Access Compliance Report Public Rights-of-Way (Curb Ramps)

Main Street: TRIAD_LN		Cross Street: N/A		Location:	NE
-----------------------	--	-------------------	--	-----------	----

ADA ID: RPRK211028122316	Ramp Type: Type 4 - Parallel	Initial Pass/Fail: Fail	Overall Compliance: No	Severity Score:	2
--------------------------	------------------------------	-------------------------	------------------------	-----------------	---

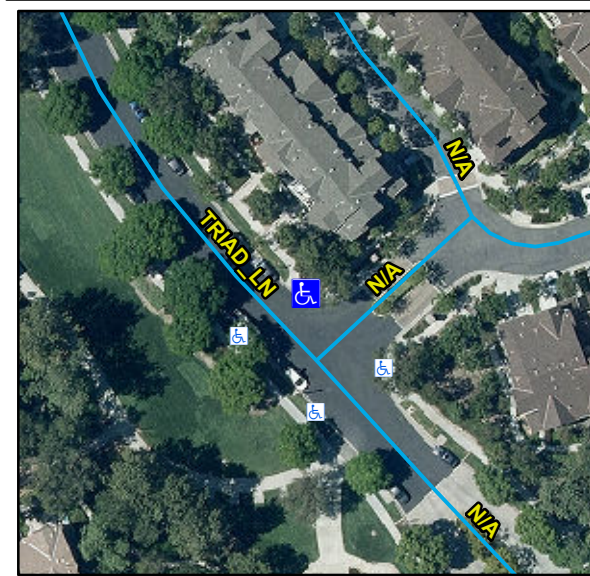
Compliance	Description	Data	Compliance	Description	Data
N/A	Ramp Length LT (in)	143	N/A	Ramp Length RT (in)	127
Yes	Ramp Width LT (in)	54	Yes	Ramp Width RT (in)	54
Yes	Ramp Run Slope LT (%)	3.4	Yes	Ramp Run Slope RT (%)	6.8
Yes	Ramp Cross Slope LT (%)	1.2	No	Ramp Cross Slope RT (%)	3.5
N/A	Landing Present	N/A	N/A	DWS Provided	N/A
N/A	Landing Length (in)	N/A	N/A	DWS Contrast	N/A
N/A	Landing Width (in)	N/A	N/A	DWS Length (in)	N/A
N/A	Landing Run Slope (%)	N/A	N/A	DWS Full Width	N/A
N/A	Landing Cross Slope (%)	N/A		DWS Offset Type	N/A
N/A	Landing Movement Obstructed?	N/A	N/A	DWS Offset Left (in)	N/A
	Landing Movement Type	N/A	N/A	DWS Offset Right (in)	N/A
N/A	Landing Shared	N/A			
N/A	Clear Space	Yes			
N/A	Clear Space To Crosswalk (in)	N/A			
N/A	Marked Crosswalk 1	No	N/A	Marked Crosswalk 2	No
	Crossing 1 Direction	W		Crossing 2 Direction	S
N/A	Marked Crosswalk 1 Width (in)	N/A		Marked Crosswalk 2 Width (in)	N/A

Remove & Replace Curb Ramp With Two New Directional Ramps or Equivalent.
